AUTHORS' REPLIES TO RC2 COMMENTS

Replies to general comments

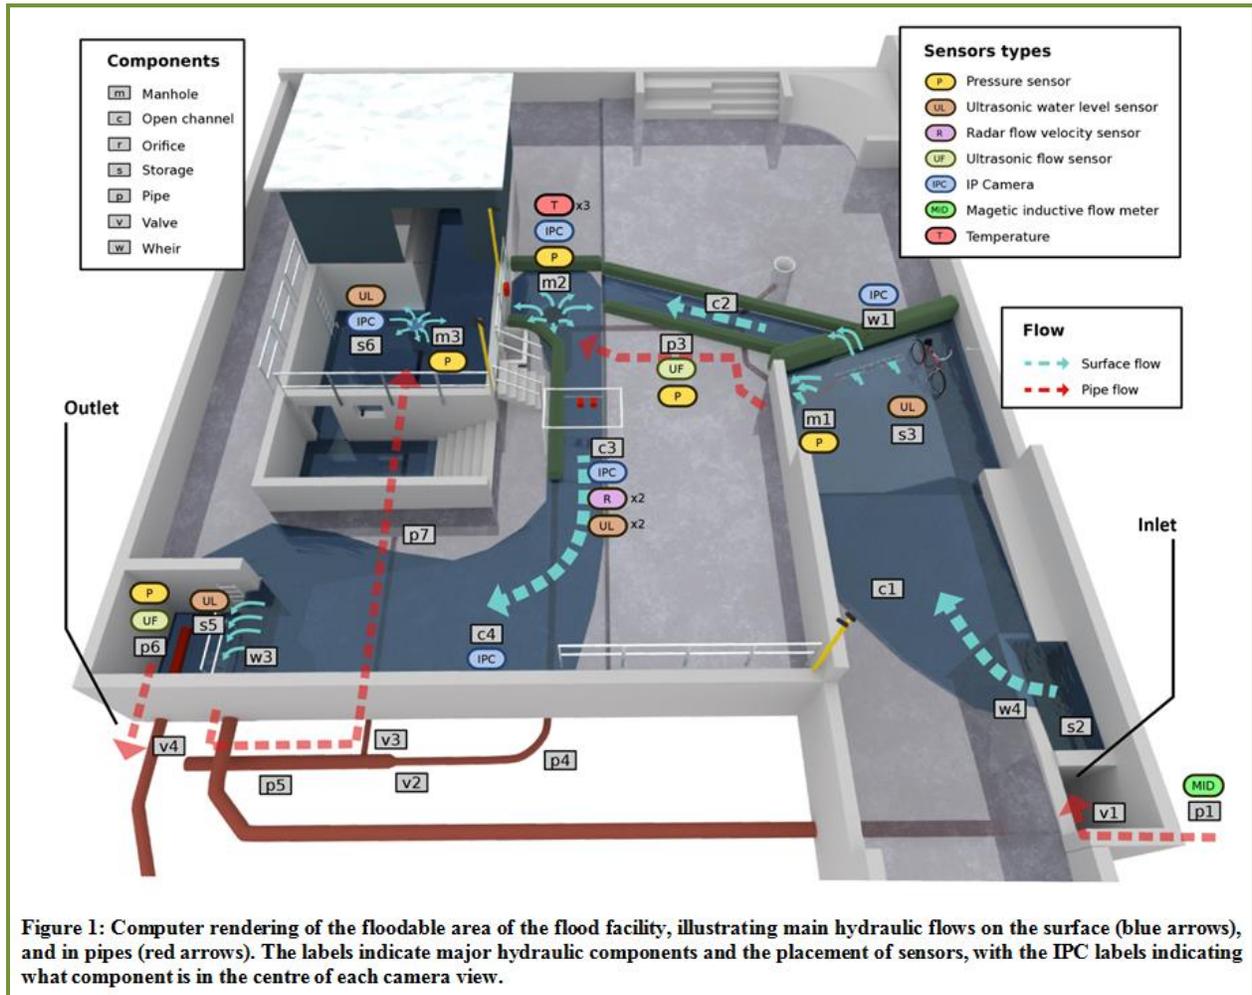
RC2.4 *The drainage system, manholes and constructions are not really visible on this picture.*

Authors: Following a similar comment from reviewer 3, the figure has been replaced with a computer rendering of the setup in which the drainage system, manholes, and constructions are visible, along with arrows indicating flow direction.

Changes: The following figure has replaced Figure 1:

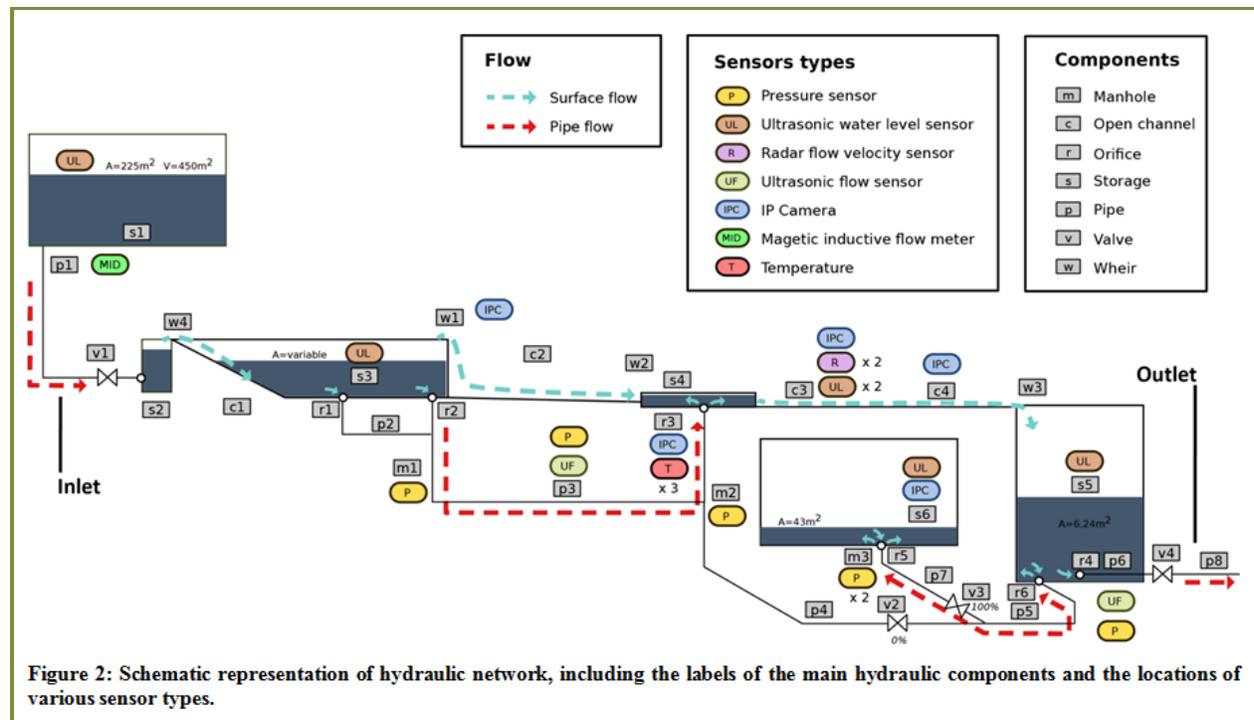
RC2.6 Not very clear, a little too schematic. It seems that the model includes one single pipe and one single manhole according to this figure which is very simplified if compared to "real" urban flood situations.

Authors: Figure 2 has been adapted to make it easier to read. In combination with Figure 1, where the same style has been used, the readers will now be able to visualize the experimental setup.

Changes: Figure 2 has been adapted in the following manner: the same symbols, colors, and line styles are used as in Figure 1; manhole openings and orifices are indicated differently to make them more visible, overland flow channels are included.

Figure 3: Water level behind dam s3 measured by ultrasonic sensor s3_h_us_maxbotix. The measured level in absence of water can be seen varying over time. At 14:30 (rectangle to the right), the level is lower than at 13:00 (rectangle to the left).

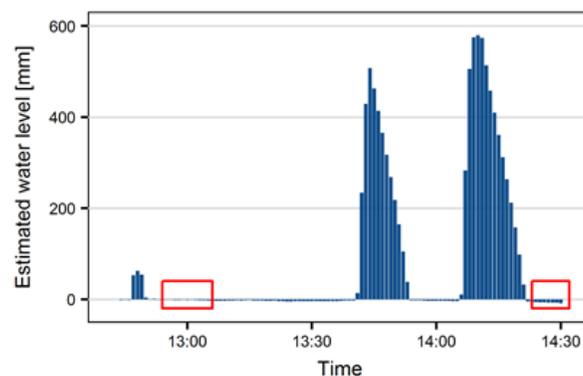
RC2.30 *I do not understand what we should look at. What does this figure represent (successive filling and emptying?). Where is the drift? What do the red circles show?*

Authors: We agree that the figure was not clear.

Changes: The legend of the figure has been made more descriptive and the clarity of the figure has been improved.
